Sheet: /Head_Line_Driver/ File: Head_Line_Driver.kicad_sch					
		Jilver.kicau_scii			
	Title:				
	Size: A3	Date:			Rev:
	KiCad E.D.A. kid	ad (6.0.9-0)			ld: 8/15
					A

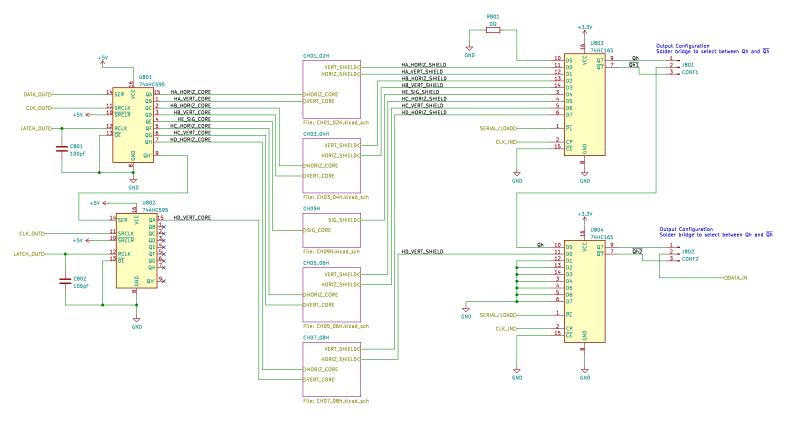
Q: Will there be any transmission effects? i.e. by sending the signal down a possibly 20m cable. It is not inteded to be a pulse but a purely a change in state.
